APPEAL SUMMARY

Appeal ID: 27504	Project Address: 2821 NE Davis St
Hearing Date: 2/16/22	Appellant Name: BRENDON FARRELL
Case No.: B-003	Appellant Phone: 503-235-5142
Appeal Type: Building	Plans Examiner/Inspector: Anne Schmidt
Project Type: commercial	Stories: 1 Occupancy: A Construction Type: V-B
Building/Business Name: GUERO	Fire Sprinklers: No
Appeal Involves: Erection of a new structure, Alteration of an existing structure, Addition to an existing structure, occ Change from S1 to A2 / S1	
LUR or Permit Application No.: 21-114606-CO	
Plan Submitted Option: pdf [File 1]	Proposed use: RESTAURANT

BUILDING CODE APPEAL

2 FLOOR PLAN DIAGRAM
SCALE AS NOTED

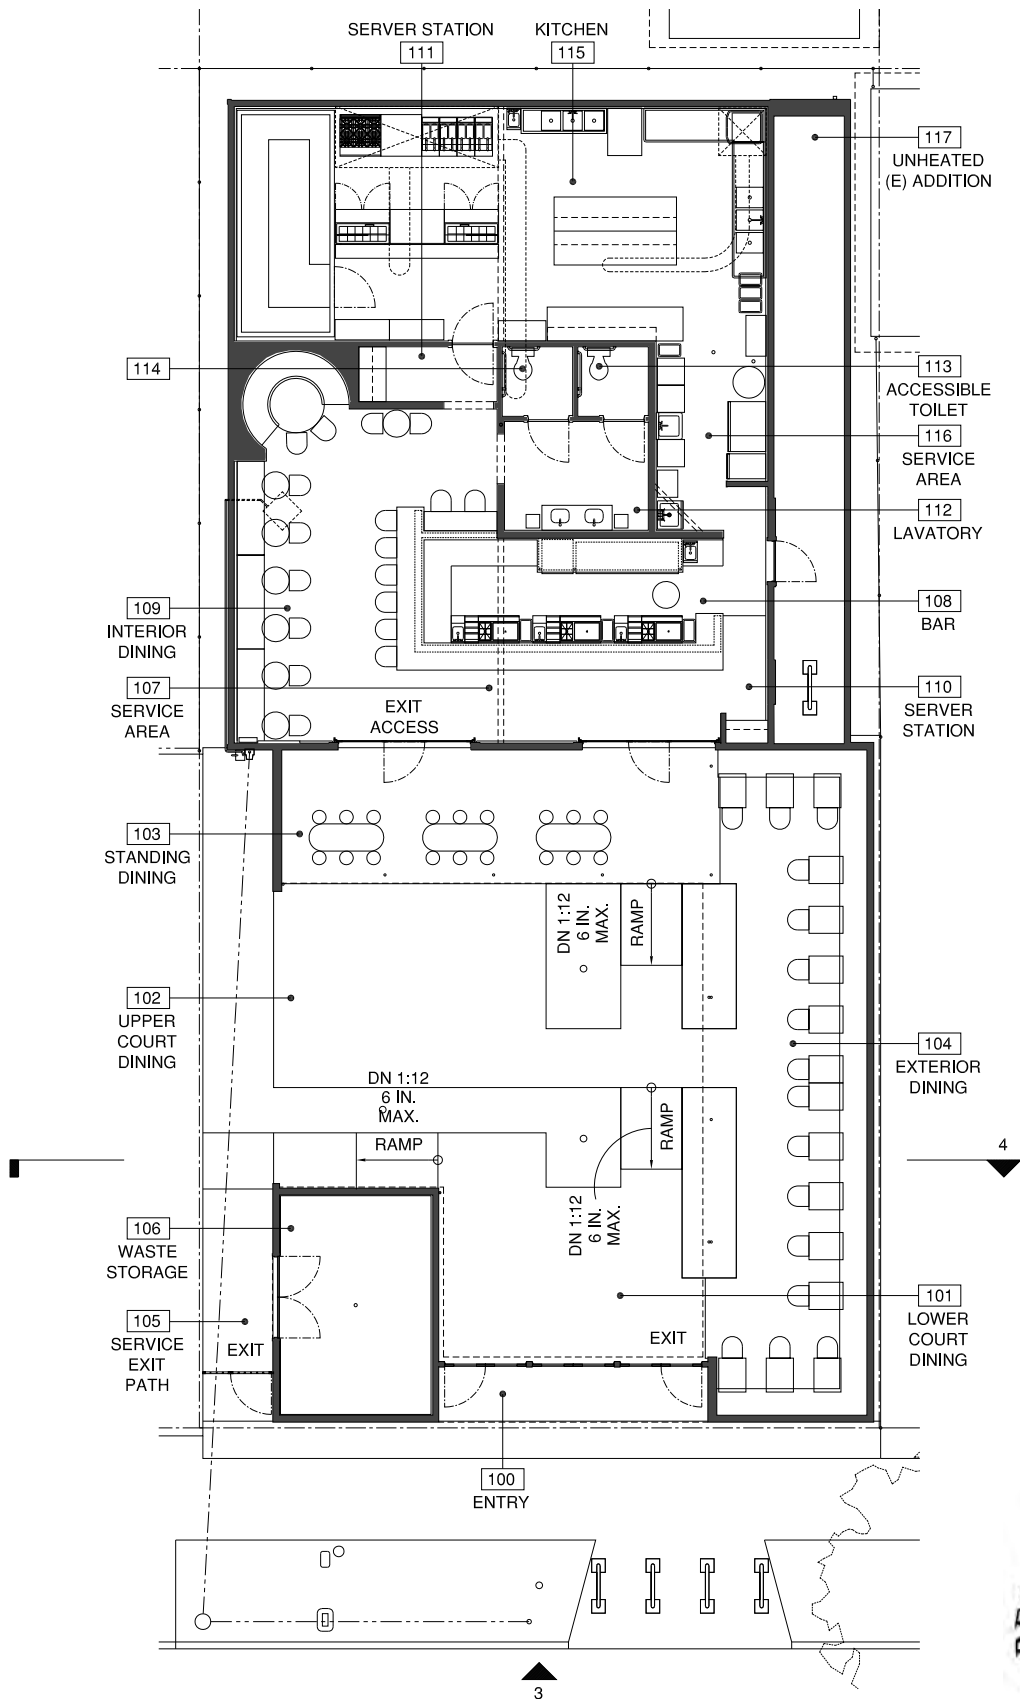
Appeal item 2

Requires	2019 OSSC – EXIT SIGNS 1013.1 Where required Exception # 2. Main exterior exit doors or gates that are obviously and clearly identifiable as exits need not have exit signs where approved by building official.
-----------------	---

Code Modification or Alternate Requested	Approve exception #2 at the main exterior exit door to street.
---	--

Proposed Design	Two exits are provided from the open air private court. First exit path from private court is open air to main exterior door at street. Second exit path from private court is open air to an open air gate at street. Exit sign with direction provided on second exit path from private court to open air gate at street. Doors are to remain unlocked when property is occupied. Existing and new construction provides wall rating, door rating and parapets as required. All egress paths are accessible with illumination as required.
------------------------	--

Reason for alternative	Main exterior door from private court to street is obviously and clearly identifiable as an exit.
-------------------------------	---

2. Omission of exit signage at the main exterior exit door to street: Granted as proposed.

5 FIRE AREA, RATING & EXIT PLAN DIAGRAM

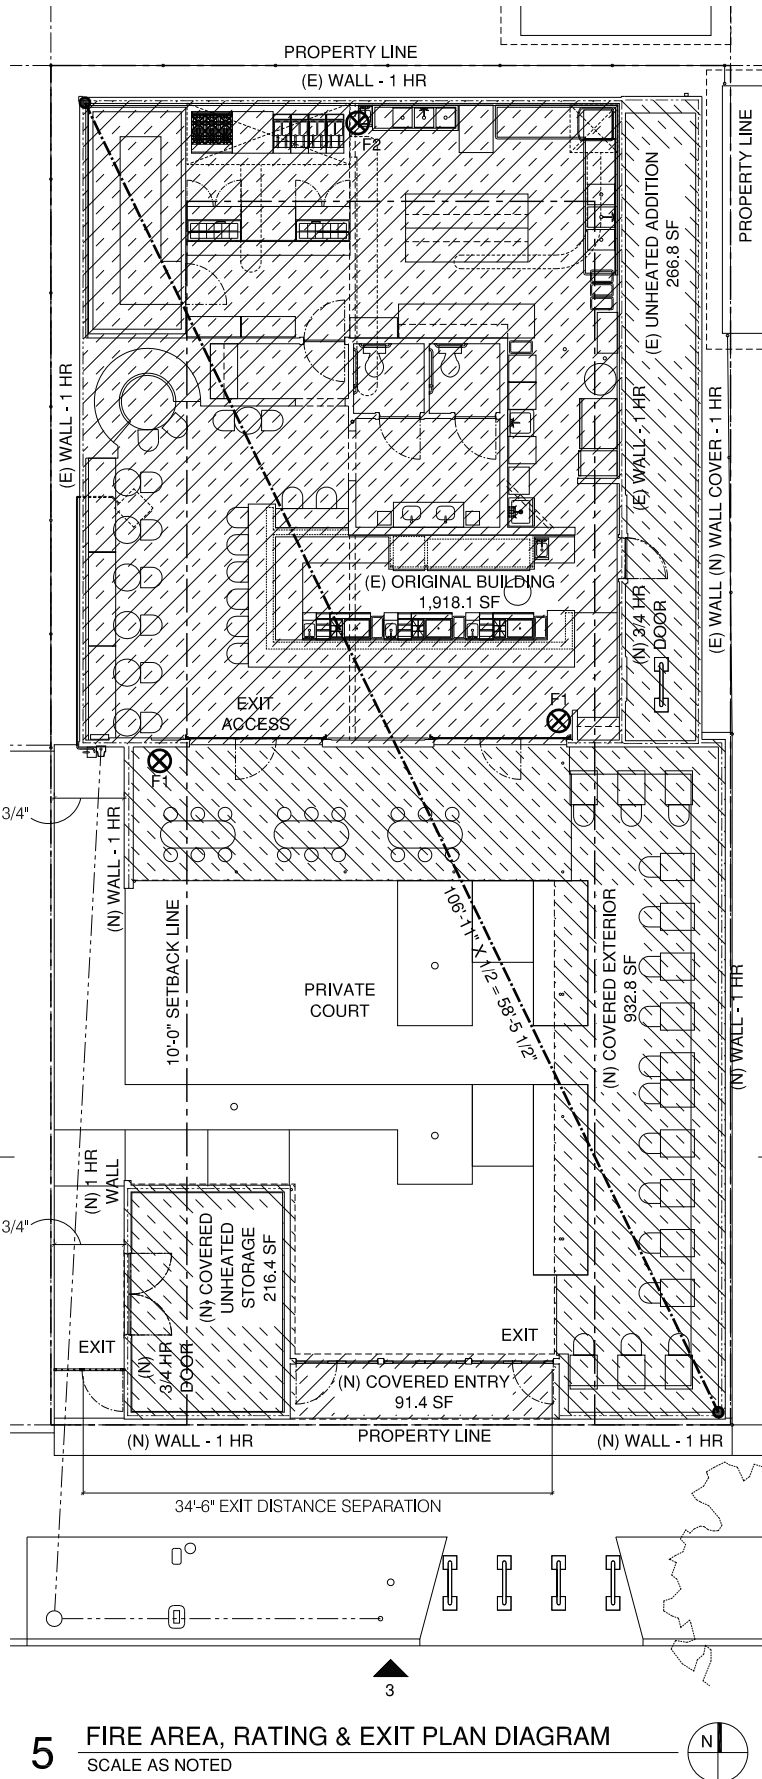
Code Section 1007.1

Requires 2019 OSSC – 1007.1.1 Two exits or exit access doorways
Where two exits, exit access doorways, exit access stairways or ramps, or any combination thereof, are required from any portion of the exit access, they shall be placed a distance apart equal to not less than one-half of the length of the maximum overall diagonal dimension of the building or area to be served measured in a straight line between them.

Code Modification or Alternate Requested Reduce exit distance separation requirement.

Proposed Design Occupant load and area to remain under threshold requiring sprinklers at an A2 Occupancy.
Total egress path distance is 85.5% (171'-2") of the allowed non-sprinkler egress path distance (200'-0")
Single exit is provided from the existing building to a new open air covered area and open air private court.
Two exits are provided from the open air private court.
Exit distance separation between the two exits is 34'-6".
First exit path from private court is open air to door at street with a 4 foot depth weather protection on street side.
Second exit path from private court is open air to an open air gate at street.
Doors are to remain unlocked when property is occupied.
Existing and new construction provides wall rating, door rating and parapets as required.
All egress paths are accessible with illumination as required.

Reason for alternative Required exit distance separation (53'-5 1/2") is not possible along the (50'-0") street property line.

1. Reduction in exit separation distance from 58 feet six inches to 34 feet six inches: Granted provided the occupant load and omission from sprinkler requirements are verified at time of Life Safety plan review and provided exit signage is posted on the North wall of the Waste Storage structure near the West corner in addition to exit signage at the gate discharge.
